**Project Facts**

**Project Summary**

The Applicant proposes to demolish the existing 3,400 sq. ft. building and construct one new building for a new Vehicle / Equipment Service and Repair – General (vehicle oil change facility) use on the site. The building to be constructed with this site plan is a twenty-foot-tall single-story structure that is 1,415 sq. ft.

Staff recommends approval of Project # SP-2022-03, Site Plan for Take 5 Oil Change, subject to the following conditions:

Building Site Plan

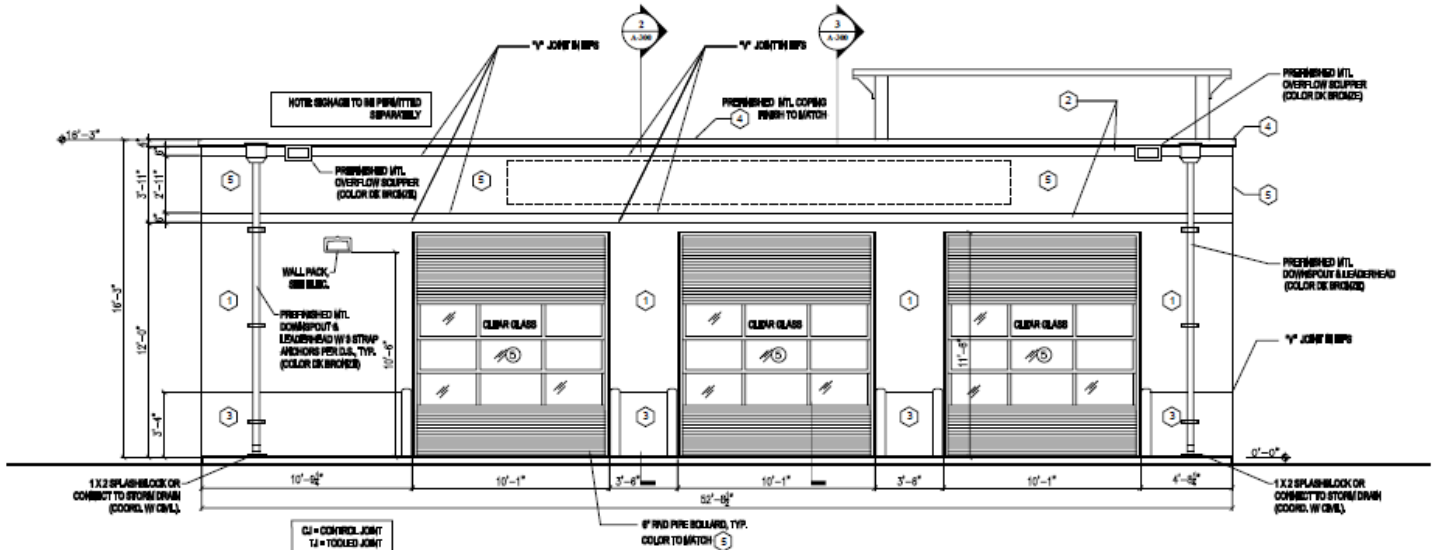
- *Article 6: The Landscape Plan complies with Article 6 planting requirements.*
- *Article 7: The site plan complies with Article 7: Access & Parking Standards. The site plan meets the intent of the driveway access width requirements provided in Table 7-2: Driveway Width, with a unique circulation pattern that splits the entrance and access locations. The wide curb radius and lack of proposed sidewalk along Eisenhower is problematic, but this is a unique site condition. Ideally, either the City or applicant would improve the side street to the City Standard for the right-of-way in this area. However, the more viable option would be to treat this as a deficient existing condition. The ability to establish and connect sidewalks along Eisenhower is limited due to the location of utilities and other limitations within the site and right-of-way. The applicant has proposed a connection of the 5ft sidewalk into the reconstructed parking lot though, which helps to reinstate the current level of pedestrian facilities to the site.*

- *Article 8: Lacking information. The proposed placement and size of the Freestanding monument sign along K-7 generally meets the standards of Table 8-2: Sign Allowances. The application proposes two signs each of 25 s.f. in area spaced sufficiently from one another, but the overall requirements of the code will only allow placement of one sign. Staff recommends that the sign along K-7, which meets the 10ft setback requirement from the street be the single monument sign allowed on the property. It is worth pointing out that this sign will be limited to a maximum height of 6' due to its proximity to the street.*

- Compliance with the City's no net increase policy is still under review as a stormwater / hydrology report needs to be completed.
- A Traffic Impact Study needs to be prepared and submitted to show that no adverse effects will occur for the K-7 corridor nor Eisenhower. This report will also be shared with KDOT for review.
- The alleyway to the east side of the proposed project should be improved as part of this project, especially since it will be utilized for entrance to the site.
- Other minor comments shown on the plans.

- Plumbing code only requires cleanouts on the service line every 100'.
- How will the drainage inside the building be handled? Will there be drainage pits inside the building that are connected to the sewer system – thereby creating a need for a grease / oil separator to protect the City's infrastructure?
- Lateral design should be reconsidered – Wye's are not permitted fittings and a cleanout located in the alley would likely not mix well with snow removal operations / etc.

1 NORTH ELEVATION  
 A-200 1/4"=1'-0"

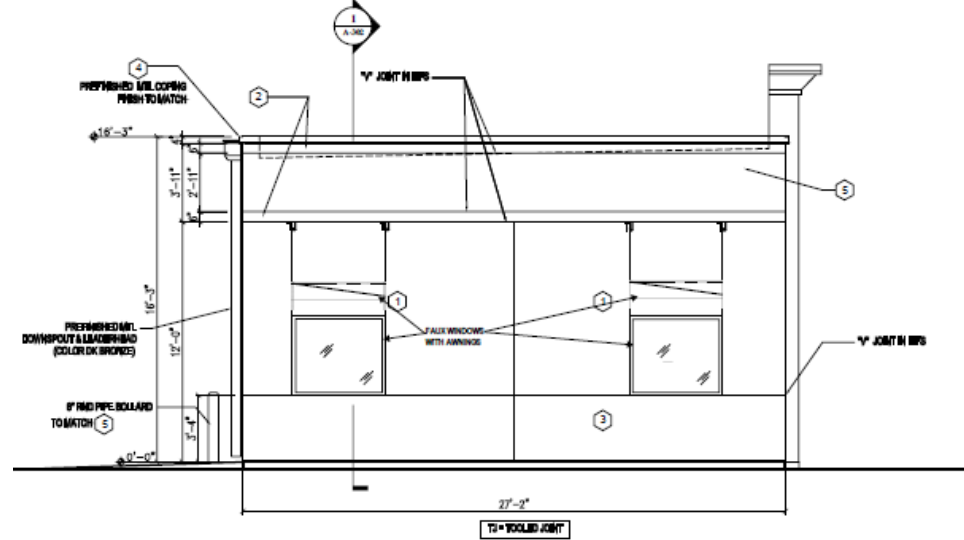
- *Article 5: The Site Plan & Elevations comply with the "Terrace" frontage type application – Setback of 10ft on K-7 (west elevation) and 24ft on Eisenhower (north elevation). For the B-3 Zoning designation, this frontage type is indicated as "preferred", with applicability based on surrounding development pattern, street section designs, and site plan. The proposed use, existing context along K-7, and small lot size make full compliance with the standards of the Terrace frontage type challenging, specifically with regard to Massing & Composition standards. Since this is an automobile-service use, entryways are limited to the east elevation (rear-facing) and the applicant has attempted to meet the intent of the Massing & Façade Composition standards in Table 5-6 through the application of service bays on the north elevation and faux windows with awnings and landscaping screening (Emerald Green Thuja) along the west elevation.*

*Additional wall signage is indicated on the elevation drawings, amounting in an unclear number of signs. It is noted that signage will be permitted separately from the site plan process, which is correct as it would be reviewed during the building plan submittal and approval process. If approved, the applicant must agree in writing to comply with any standards regarding signs and specifically outlined for Wall Signs in Table 8-2: Sign Allowances:*

- *Number: 2 signs per tenant with exterior entrance (multi-tenant building) – otherwise 3 per façade maximum.*
  - *Total Area Allowance: 10% of façade area maximum.*
